REFERRAL COMMENTS

Variance (Area): V-18-07
Address: 115 PARK AVE, Syracuse,

Request:
Establish a parking lot.

V-18-07

GRADING & DRAINAGE PLAN
 113-115 PARK AVE
 SYRACUSE, NY

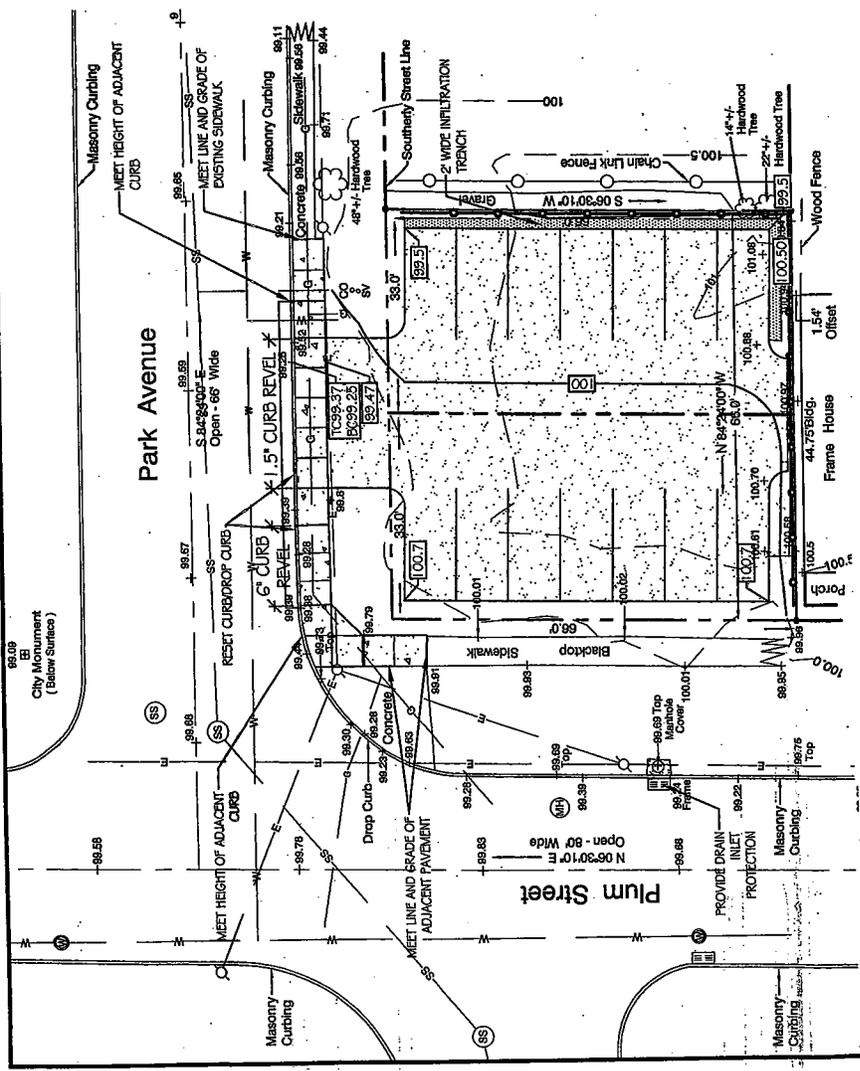
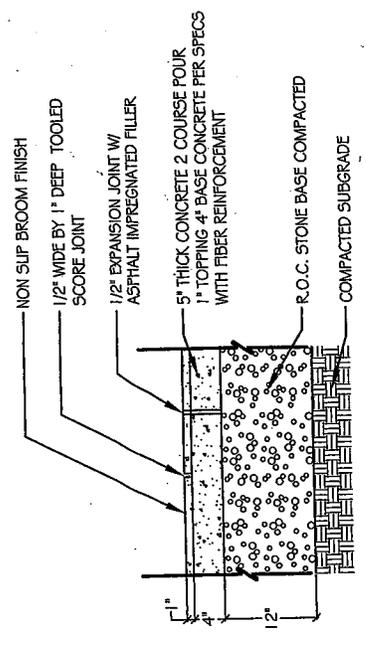
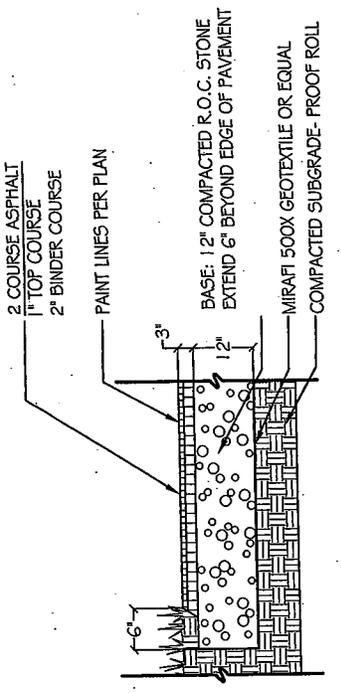
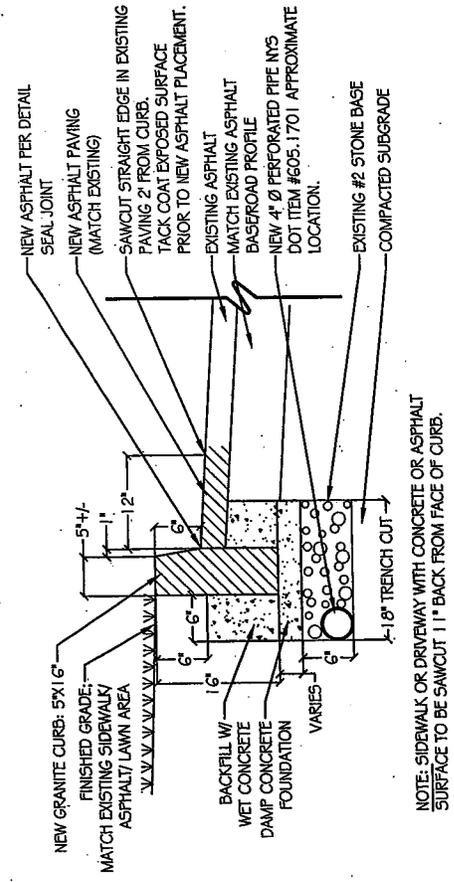
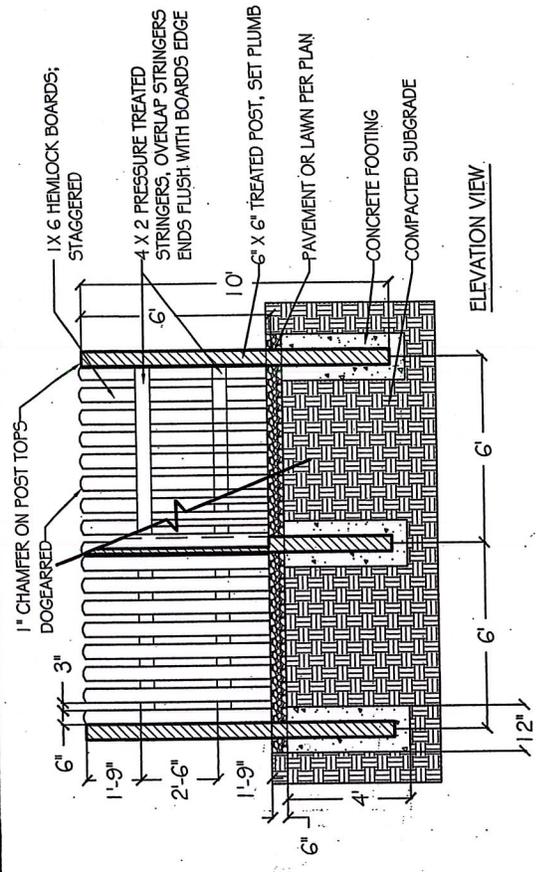
Eng. Design & Cons. - Zoning	Internal Review Complete	01/18/2018	Charles Davidson	Refer to engineering comments for Bldg. Permit 30699 and 30700. If applicant addresses engineering comments, there are no objections with variance. 1. The grading plan currently shows sheet flow of storm water being directed to the City ROW and adjoining properties. The grading plan shall be

revised so that all Storm water / Roof Drainage is contained on site.

2. The Southern edge of the proposed parking lot shall be revised to be straight along the whole length. There shall be a continuous and consistent buffer of green space between the proposed parking lot and all adjoining properties.

3. Plans do not show/label the material between the proposed parking lot and the sidewalk.

4. The City recommends replacing all blacktop sidewalks with concrete sidewalk per City standard.

5. Sidewalk shall be installed per City, NYSDOT standard and comply with current ADA standards (2% cross slope maximum, 5' x 5' flags, etc.). Proposed sidewalk shown on plans is designed at the maximum cross slope.
